Addendum to Bally Water Resources Investigation Report

ARCADIS, on behalf of Sunbeam, is pleased to submit this letter and the attached Addendum to the Detailed Hydrogeologic Water Resources Investigation Report, Bally Groundwater Contamination Superfund Site (Site), Bally, PA (WRI Report) to address the comments that you provided in your May 9, 2006 email and subsequent May 11, 2006 conversation with ARCADIS.

**Detailed  
Hydrogeologic Water  
Resources  
Investigation Report**

Bally Groundwater  
Contamination Superfund  
Site  
Bally, Pennsylvania

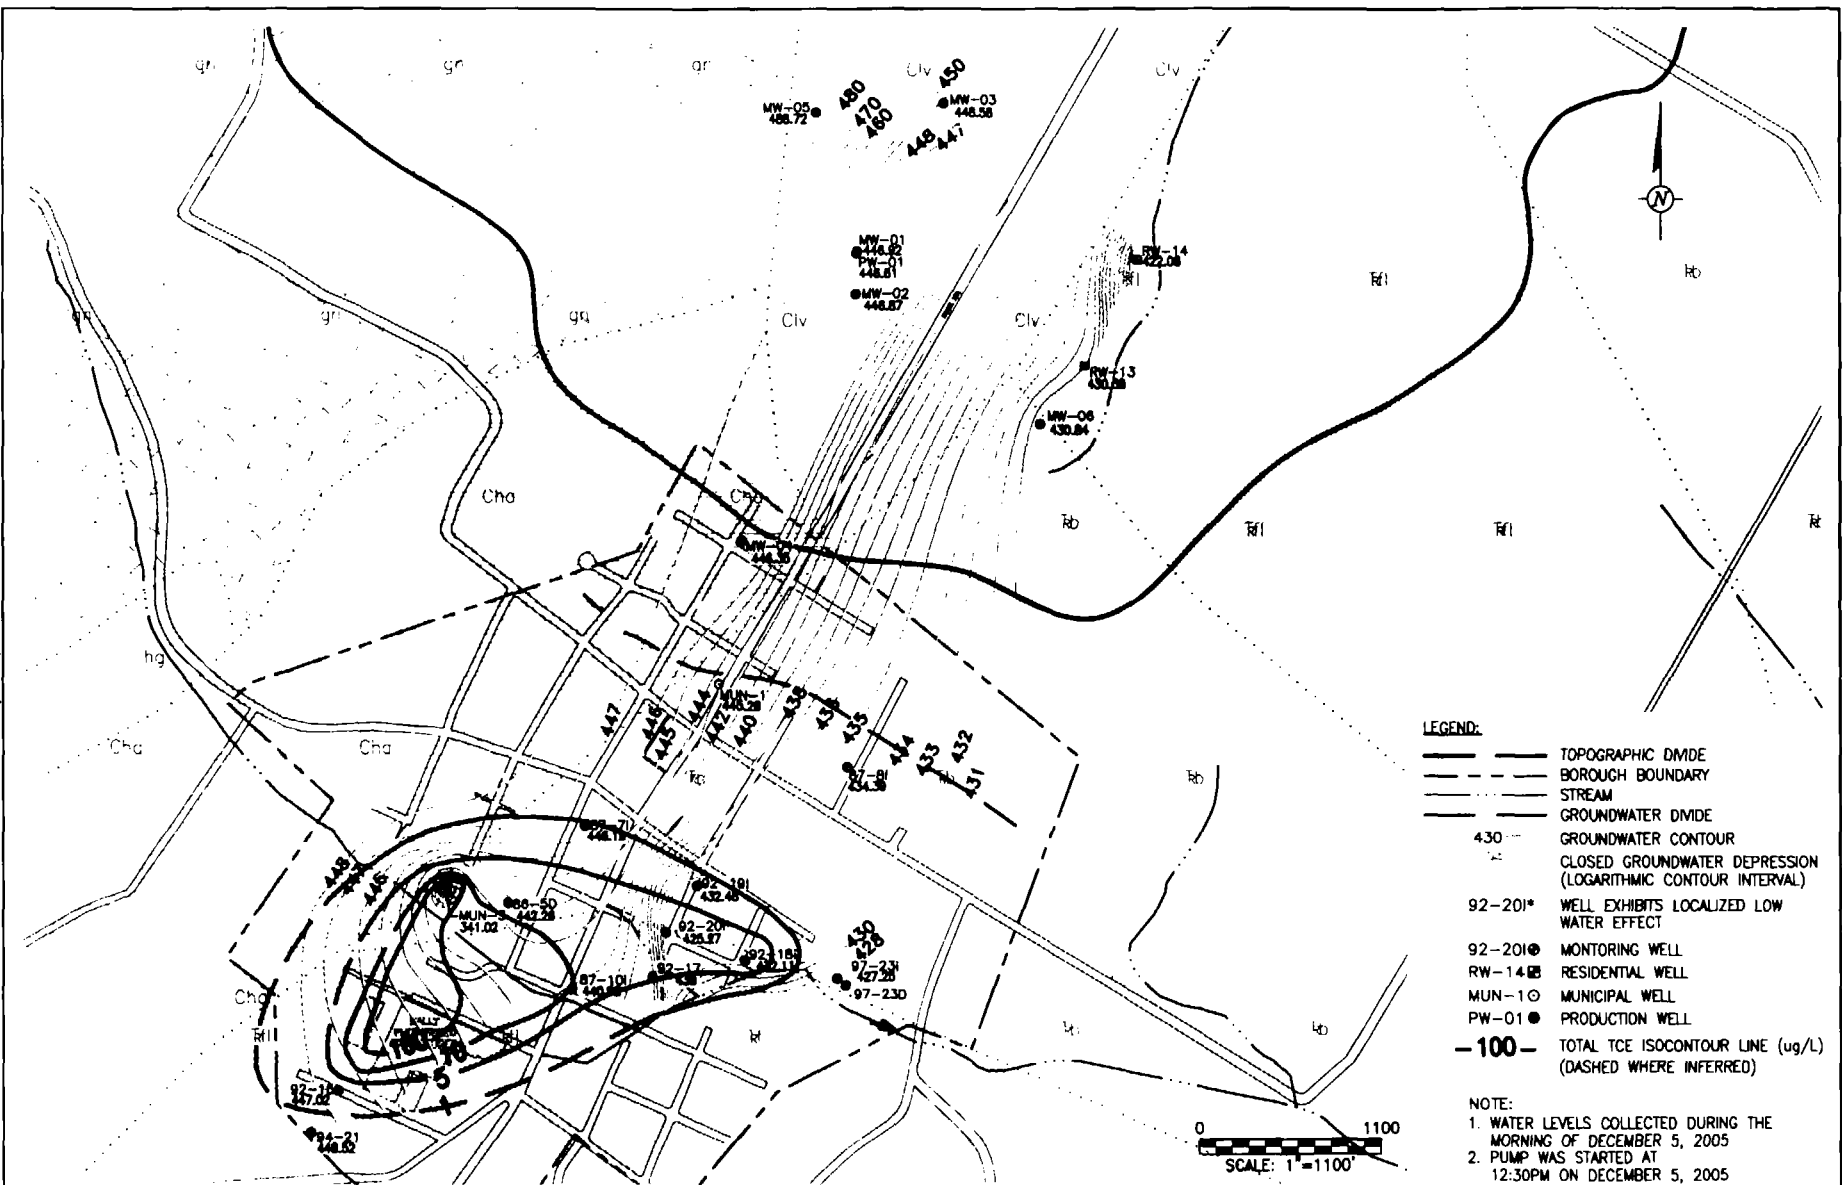
- **Figure 4 rev.** replaces **Figure 4**, to show an overlay of the TCE plume area
- **Figure 6 rev.** replaces **Figure 6**, to show an overlay of the TCE plume area
- **Figure 10 rev.** replaces **Figure 10**, to show an overlay of the TCE plume area
